**ALBERTA ENERGY AND UTILITIES BOARD**

**APPLICATION BY SUNCOR INC. OIL SANDS GROUP  
FOR AMENDMENT OF APPROVAL NO. 7632 FOR  
PROPOSED STEEPBANK MINE DEVELOPMENT****Decision No. 97-1  
Application No. 960439****1 INTRODUCTION**

APPENDIX A TO DECISION No. 97-1  
PREVIOUS TO APPROVAL No. 7632

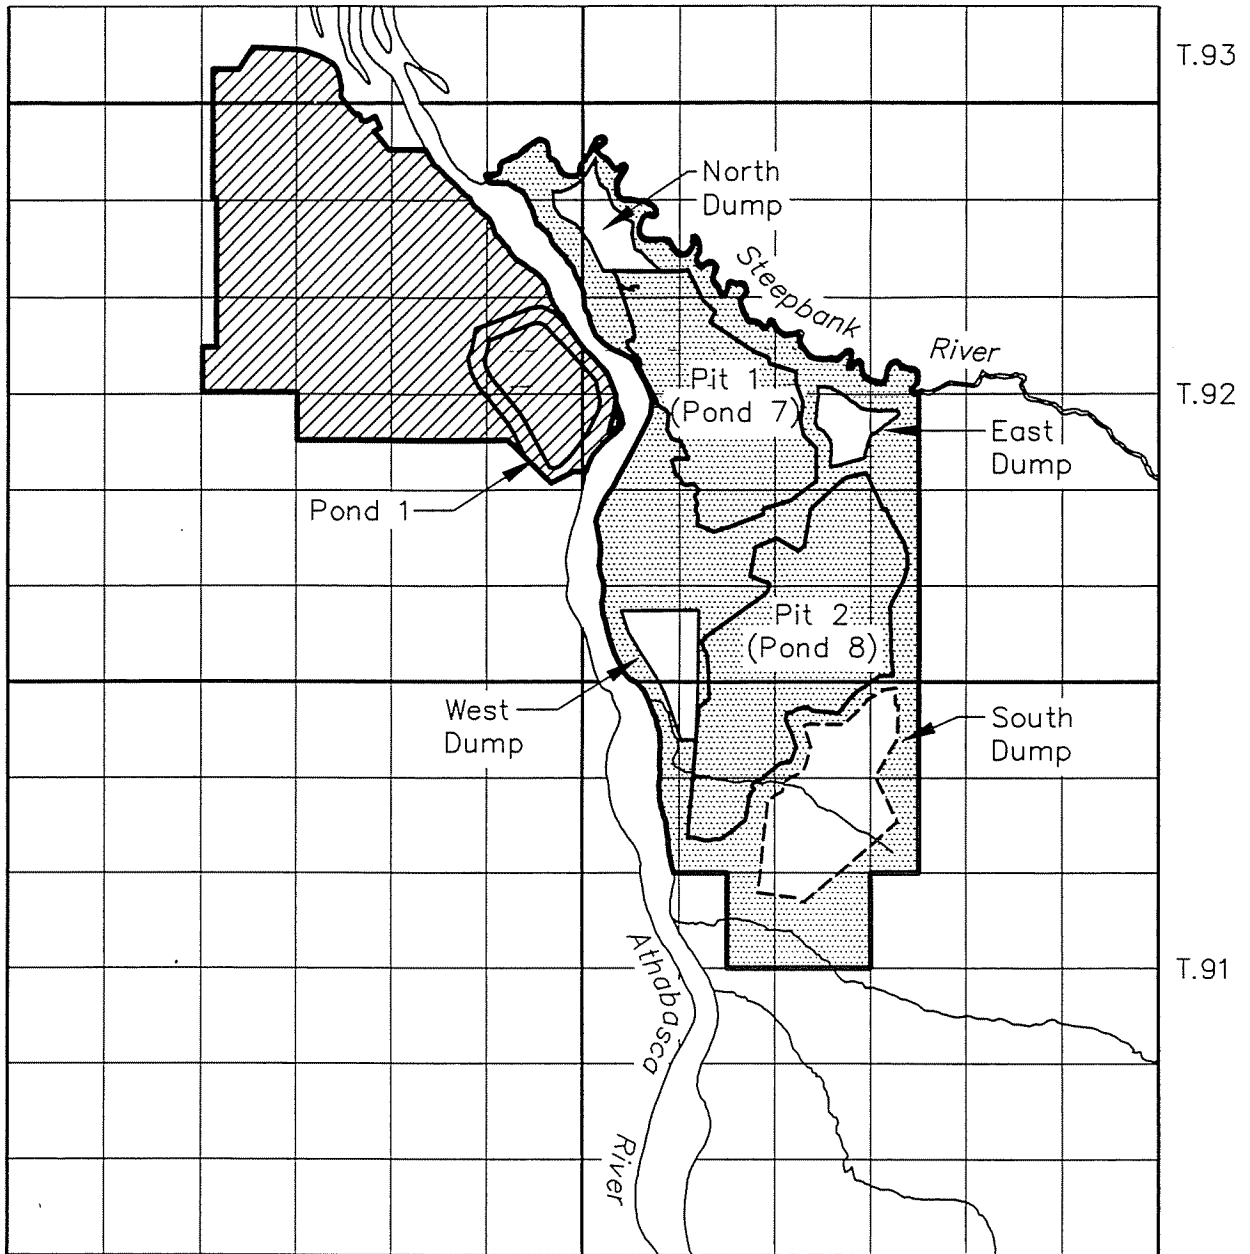
The application is restricted to the development of Pit 1 in the centre ore body on leases 97 and 25, and Pit 2 of the south ore body on leases 19 and 25. Continued development of the south ore body on leases 19 and 25, beyond Pit 2, are not part of this application (Appendix A).

- North discard site - north of Pit 1 between the lower reaches of the Steepbank River and the Athabasca River,
- East discard site - east of Pit 1 and adjacent to the south escarpment of the Steepbank River,
- West discard site - west of the Athabasca River escarpment near the area of the Shipyard Lake wetlands, and
- South discard site - south of Pit 2.

On the basis of an examination of the geological information submitted, the Board believes that the north, east, and west discard sites will not sterilize recoverable reserves. The Board, however, believes that continued drilling and evaluation is required to identify any recoverable reserves in the south discard site before it can be accepted. Furthermore, the Board believes that future drilling and refinements to pit boundaries may dictate that discard sites can be reduced in size. The Board will require Suncor to submit detailed dump designs and assessments of resource potential in the area influenced by the dumps 6 months prior to field preparation to satisfy the Board such sites and pit boundaries are appropriate.
